**Application No:** 3995/21

**Location:** Millwood Court, Woodbine Road, Raheny, D05 WQ17

### **Planners Report:**

PROPOSED CONTIGUOUS ELEVATION 1-1 TONLEGEE ROAD (NORTH ELEVATION)  
SCALE 1:125 @ A1

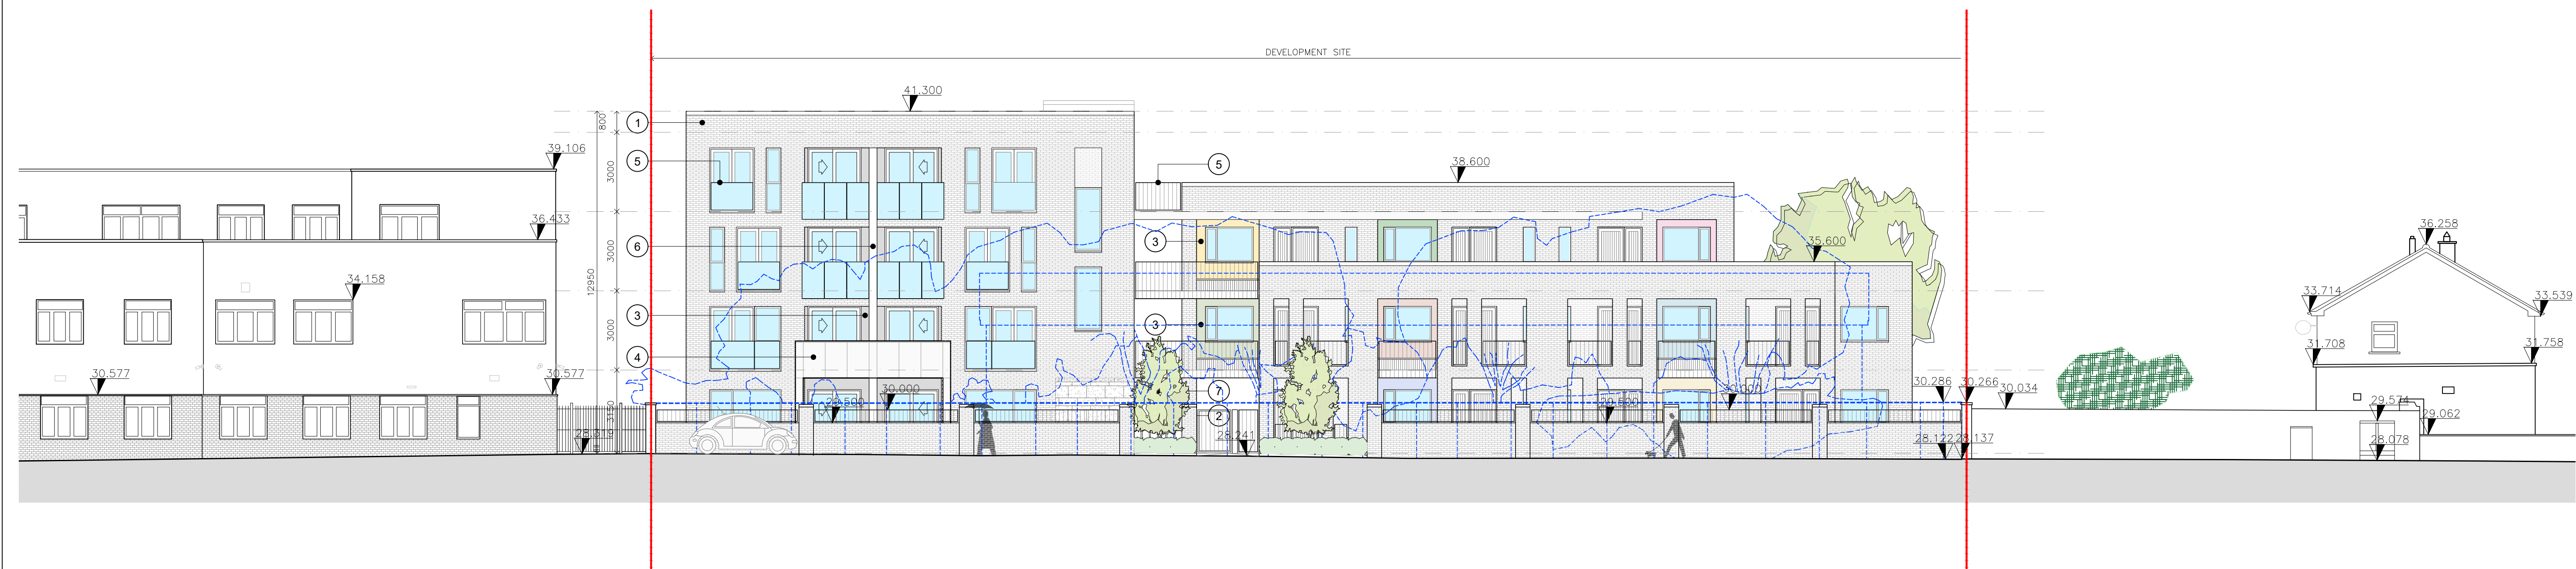
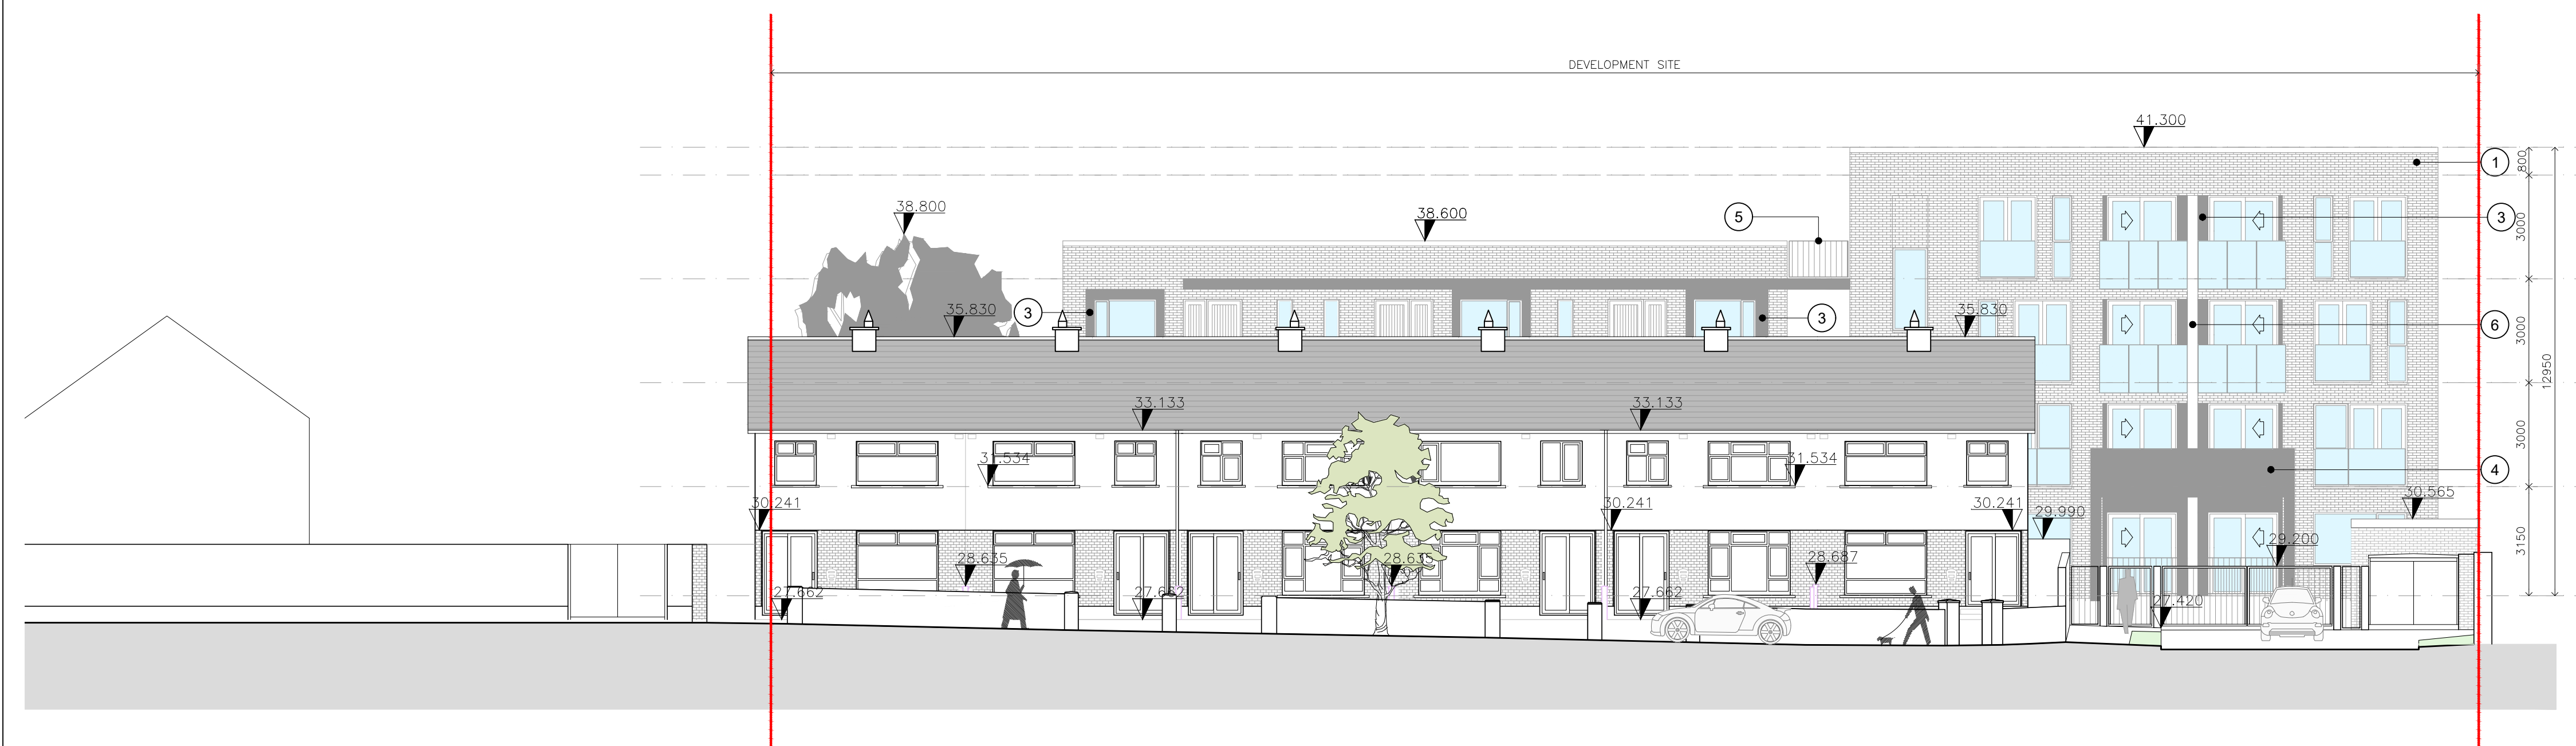
The 4-storey portion of the development facing onto Tonlegee Road will come within less than 5m of the western side elevation of the 3-storey c.11m high part -rendered-finished Tonlegee Road Primary Care Centre (PCC) (Reg. Ref. 2797/17 etc refers). Whilst in contrast to the generally surrounding low-rise suburbia it is considered that in urban design terms that these adjoining higher road-fronting elevations will provide a strong urban edge to the local streetscape and help 'contain' the wide street cross-section at this point.

While contrasting with the treatment of the upper floors of the immediately adjoining medical centre it is considered that the proposal's primarily brick treatment will provide for a potentially high quality long-lasting low-maintenance finish, and reflects the existing treatment on site. The elevations also feature stone, timber and zinc feature panels, which along with the coloured rendered recesses, where used, will provide a degree of interest and add-on some further degree of additional articulation to the elevations.

L0 - PROPOSED GROUND FLOOR PLAN  
SCALE 1:125 @ A1

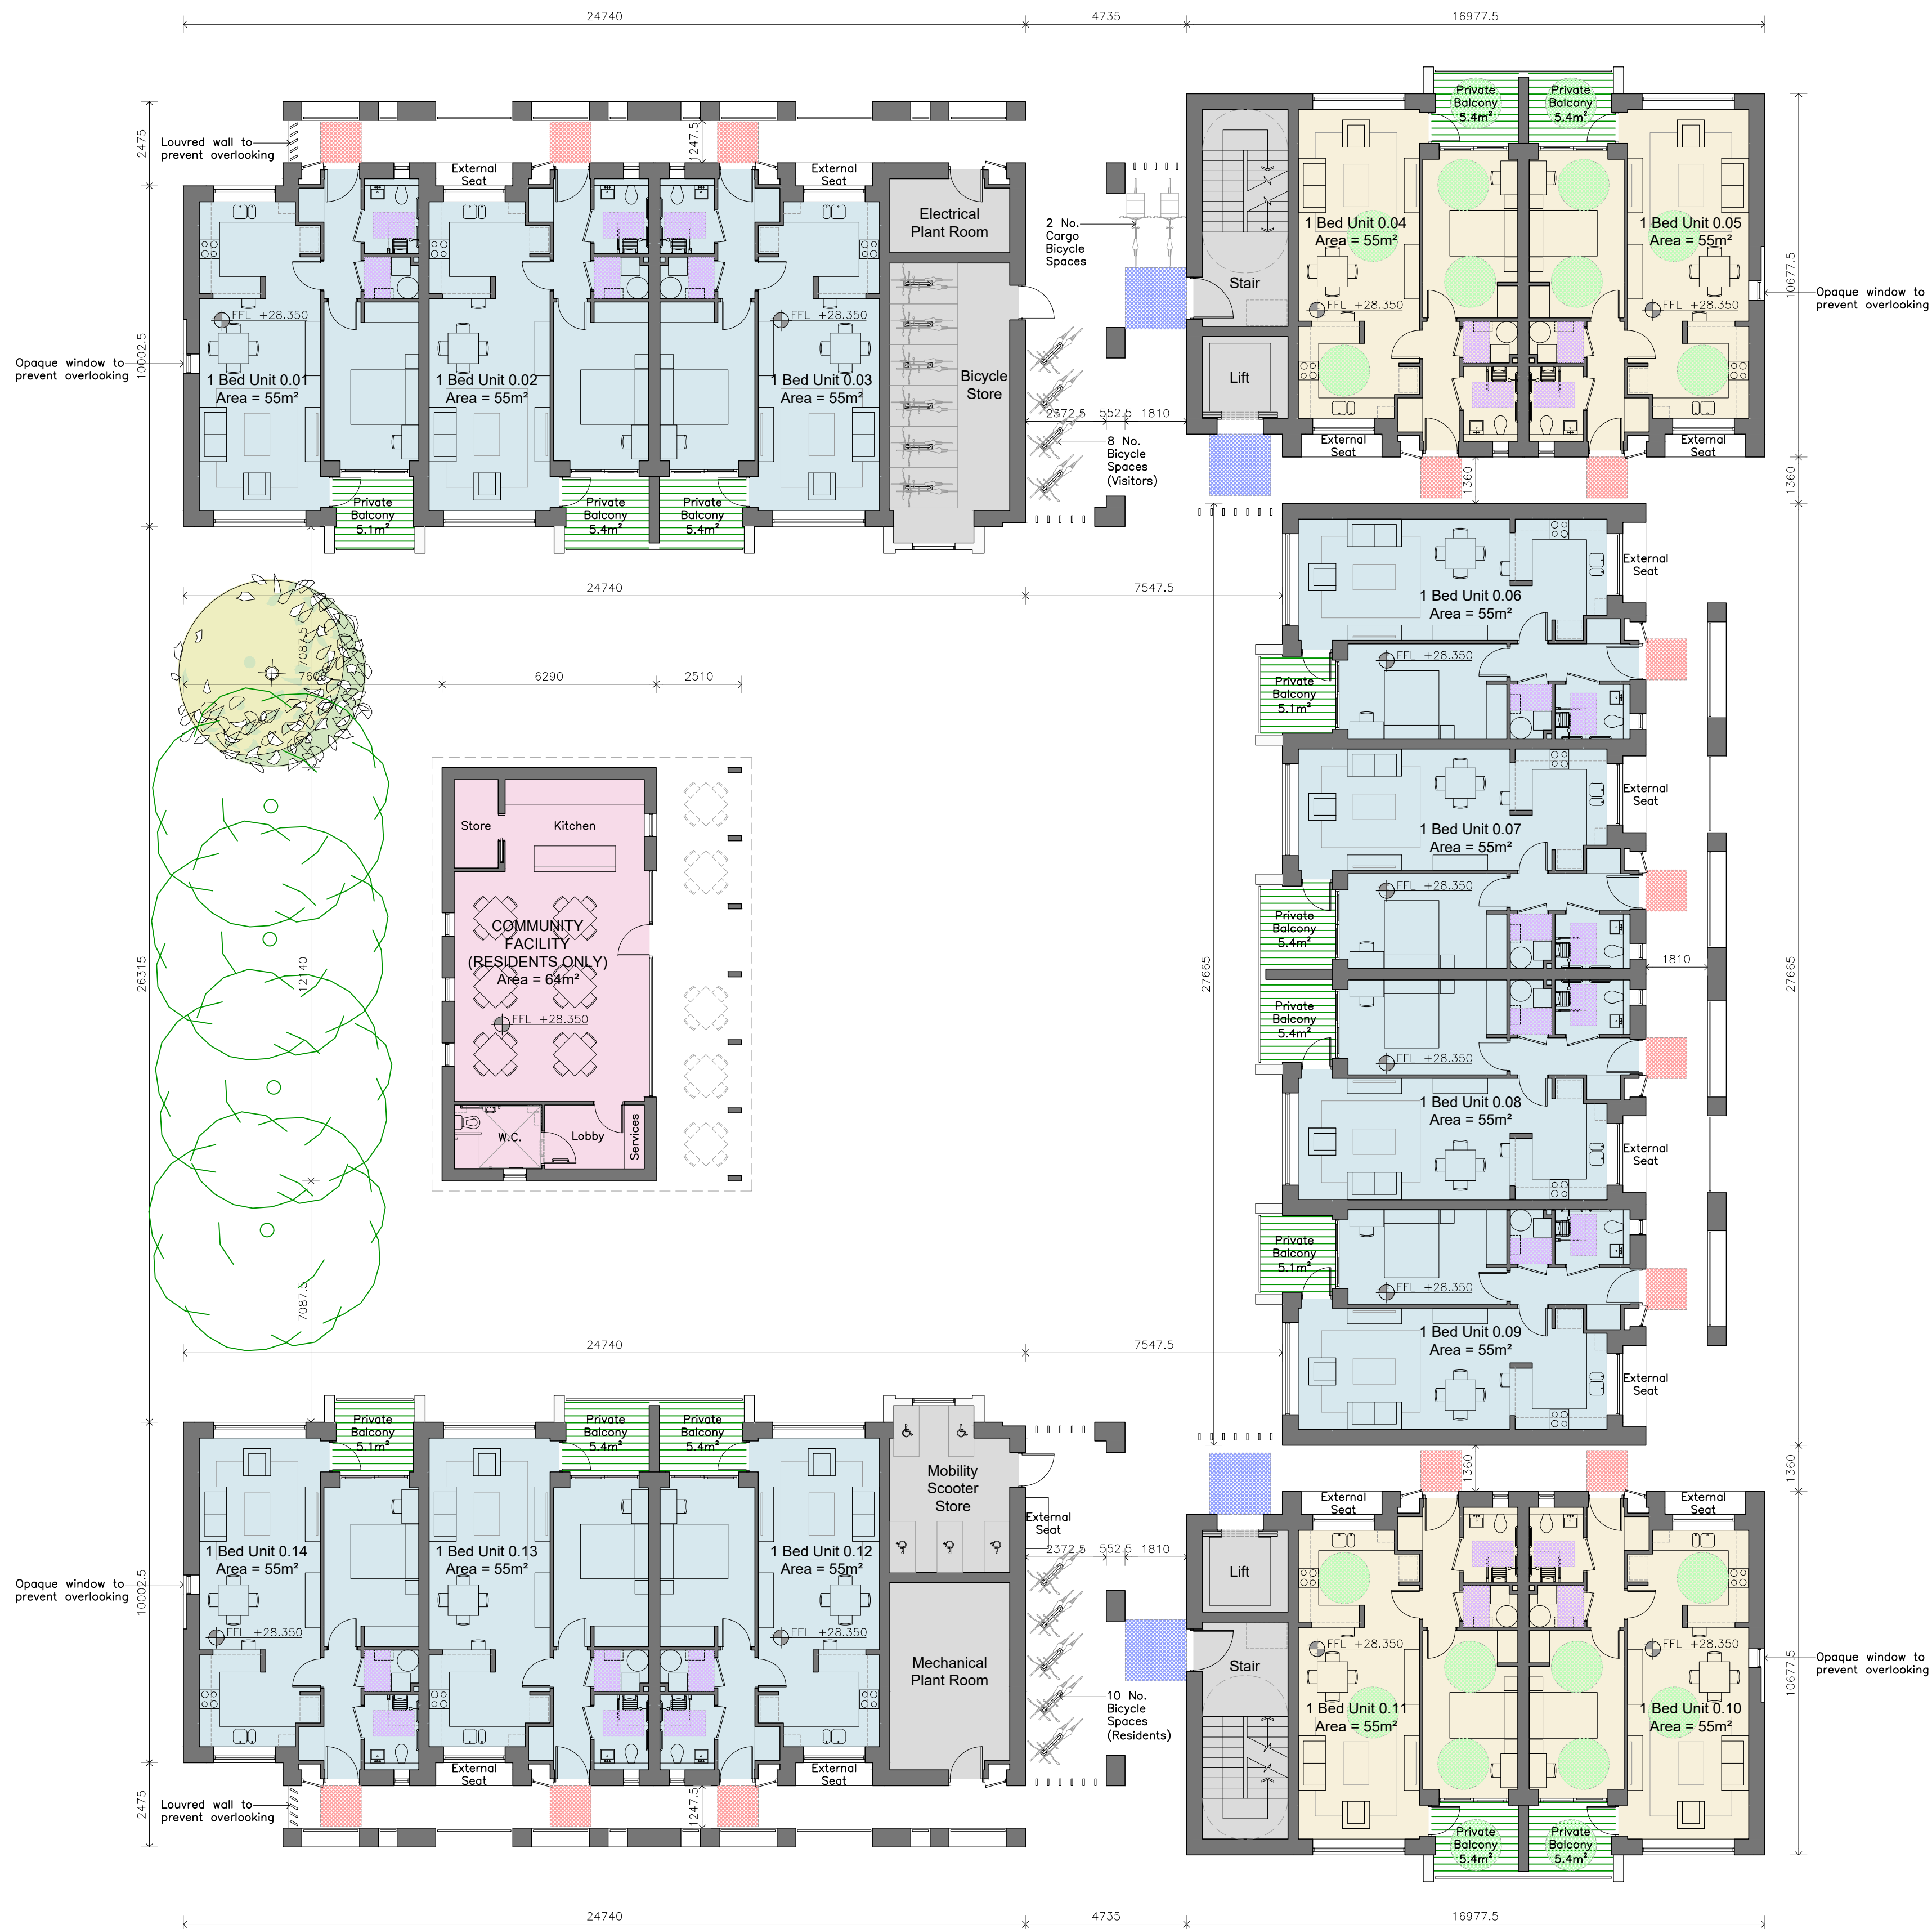
It is recommended that a low dwarf wall and/or a planting buffer/box hedge shall be placed between the surface car parking and proposed ground floor units opposite to the north so as to limit the projection of car headlight beams into apartments.

d) That a low dwarf wall and/or a planting buffer shall be placed between the surface car parking spaces and the ground floor units to the north'
